1	Explain how the changes in operation which are subject to this variation will have an impact on the designated habitats.	Reason –You previously submitted report entitled ‘Ecological Impact Assessment, Project number: 60630268’ dated December 2021 Revision 3 as part of the previous variation which remains applicable however, you have not assessed potential impacts on relevant ecological features as a consequence of the development and how the change in operation will affect the designated habitats, or set out the measures to be Hornsea Mere SPA, Lambwath Meadows SSSI, or the Local Wildlife Sites; The Moors, Burton Constable LWS and Wycliffe, North Plantation LWS. Explain in terms of source-pathway-receptor linkages how, if any, the revised operation will impact any of these designated habitats.	The Ecological Impact Assessment of Dec 2021 is still valid as the extents of the operation still fit within the ‘operation’ phase already assessed. The embedded mitigations have not changed as the well construction and surface water drainage will not change, the lighting assessment and air quality assessments have been conducted using the ‘worst case scenario’ of lighting during the drilli

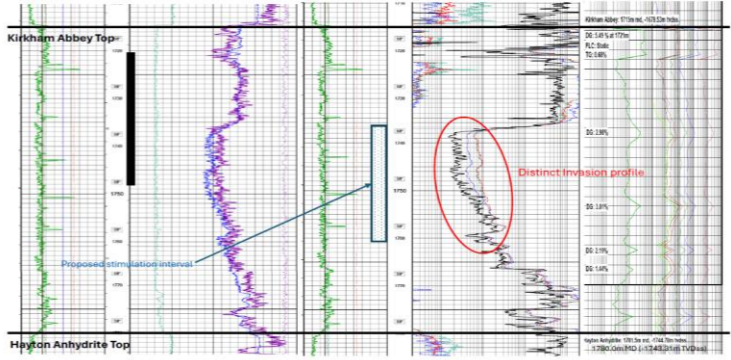
14			<p style="text-align: center;"><b>Kirkham Abbey Fm. WN A-2</b></p>  <p>The log plot displays resistivity curves for the Kirkham Abbey Formation in well WN A-2. A red oval highlights a 'Distinct invasion profile' on the micro resistivity curve. A blue box indicates the 'Proposed stimulation interval'.</p>
14	Confirm the volume of proppant fluid need for the stimulation. Explain any variations to the confirmed amount.	Reason: Supporting documents confirm 60 m3 to 70 m3, but not more than 85 m3 will be needed for the activity. This is a variation of up to 42% of proppant required.	85m3 is to include the volume used for the DFIT. This is currently unknown, so maximum volume has been specified to allow for assessment of worst case scenario.
15	Explain why both an acidic or alkali-based wash and squeeze are discussed as interchangeable.	Reason: Given the composition of adjacent lithologies being primarily compounds sensitive to acid, justification is needed for why an acidic wash might be chosen. An alkyl ester gelling agent is also confirmed as the chosen additive during the reservoir stimulation so explanation into the potential interchangeable use of an acid-based wash is needed.	To clarify, the acid / alkali wash and squeeze have already been approved in past permits. The methods are not meant to be interchangeable but as required to have the ability to use each operation if deemed appropriate. The acid / alkali wash is a common operation to conduct to wash out any residue left from drilling. The alkali fluid is often used to remove barite (which is a weighting agent used in oil based mud). The product approved to use as an alkali-based wash is actually an acid with a high pH (alkaline) and so behaves in the same way as the acid but with a lot slower reaction time than some of the low pH acids proposed.
